UNITED STATES ENVIRONMENTAL PROTECTION AGENCY

The U.S. Environmental Protection Agency has reviewed the June 5, 2019, Draft Remedial Investigation and Feasibility Study, or RI/FS, Work Plan, West Lake Landfill, Operable Unit, or OU, -3. This document was submitted on behalf of the West Lake Landfill Operable Unit-3 Respondents, Cotter Corporation (N.S.L.), Bridgeton Landfill, LLC, and the U.S. Department of Energy, to support the remedial investigation of groundwater for the West Lake Landfill Site, in Bridgeton, Missouri. The EPA is disapproving the document as submitted. Please revise the document in accordance with the enclosed technical comments.

**Technical comments on Draft Remedial Investigation/Feasibility Study
Work Plan OU-3, dated June 5, 2019**

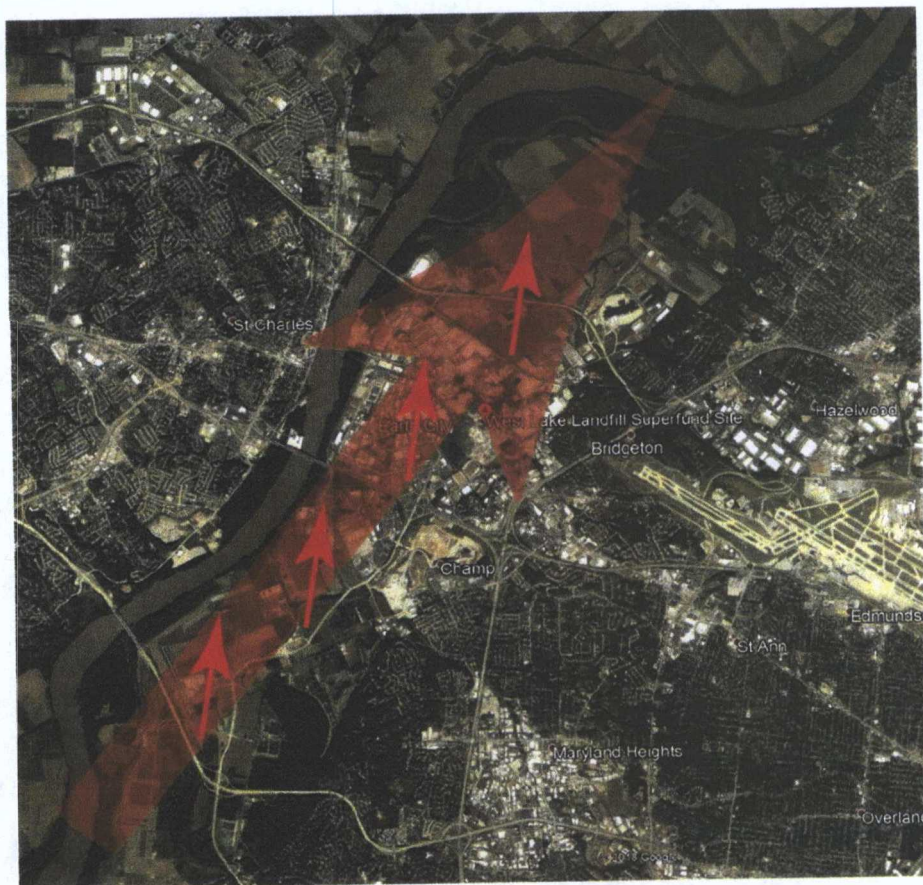
The description of the Missouri River alluvial aquifer as presented in the Operable Unit, or OU, -3 work plan is oversimplified and does not properly account for regional groundwater flow in the Site's conceptual site model, or CSM. The conclusions presented regarding general groundwater flow directions in the CSM appear to be based on a relatively small set of water-level data collected at the Site (Figures 3-11, 3-12 and 3-13a) and two previously developed water-level maps (Figure 3-1). Both of these previously developed maps have several limitations that were not included, discussed, or addressed in the work plan that significantly impacts the interpretation of general groundwater flow.

The limitations that exist for the Springfield Plateau aquifer (locally termed post-Maquoketa bedrock aquifer) water-table map (Imes, 1990; presented on fig 3-1) generally include the following items: The water-level map is for pre-development conditions; data points were limited in number and distribution; mapped at a scale of 1:500,000, water-table map does not account for the topography at a local scale, and water-table map does not account for the increased impervious surface and other anthropogenic modifications of the now highly urbanized area. The limitations that exist for the Missouri River alluvial aquifer water-table map (Burns and McDonnell, 1986; presented in fig 3-1) generally include the following items: no information on date(s) of water-level measurements; no information on the accuracy of the measurements or accuracy of the measuring point elevations; no information on the measurement method; no information on depth of the wells; no information on number or locations of the wells measured; no geohydrologic context of the measurements; no information on the precipitation events prior to the measurements; no information on the Missouri River stage/flow conditions prior to and during the measurements; no information on groundwater withdrawals near the wells prior to and during the measurements; and no mention of the transitory nature of the water-levels in the Missouri River alluvial aquifer and the time scale at which changes occur.

Further the water-level contours as shown near the Missouri River in Figure 3-1 in the alluvium do not represent 'normal' groundwater flow conditions in this area. The presented contours have an orientation that indicates little to no flow down the river valley which is contrary to the generally accepted view of groundwater flow in all alluvial valleys. The EPA notes that the contours presented in the Work Plan could potentially have this orientation temporarily following a relatively lengthy period of low Missouri River stage when the alluvial aquifer is equilibrating with the river stage, and/or after a significant recharge event, and/or when water-levels are equilibrating to the 'normal' river stage from a sustained high flow event in the Missouri River. However, using the limited set of water-level measurements and derived contours without considering the overall state of the transient groundwater flow system and the limitations in the previously developed maps (see below) leads to the misinterpretation and oversimplification of the alluvial groundwater system as currently presented in the draft OU-3 RIFS Work Plan. Based on these concerns, EPA requires the work plan be revised generally as follows:

- Indicate where appropriate that the 'normal' or quasi-steady state flow direction in the alluvium is primarily down the Missouri River alluvial valley with a subcomponent of flow towards the Missouri River. This flow condition assumes long-term stable river stage, no recent precipitation events, and no well withdrawals.
- Based upon this information, propose new upgradient and downgradient sampling/well locations to validate/refute the concept that regional flow in the alluvium is primarily down the Missouri River alluvial valley and not directly towards the Missouri River.
- Revise Section 6.2.1 of the work plan to state that a groundwater model work plan will be developed and submitted to the EPA and the MDNR that accommodates the concept of groundwater flow

discussed in this comment, i.e. alluvium groundwater flow is primarily down the Missouri River alluvial valley.

- Propose sampling and water-level data collection frequency in groundwater and surface water to account for transitory nature of alluvial system on timescale of hours/days for river stage fluctuations or precipitation events to months/years or longer for long-term items such as geo-morphic and climactic changes in the system.
- Update Figure 3-1 to depict regional groundwater flow generally consistent with the figure included below. The red arrows indicate anticipated flow direction.
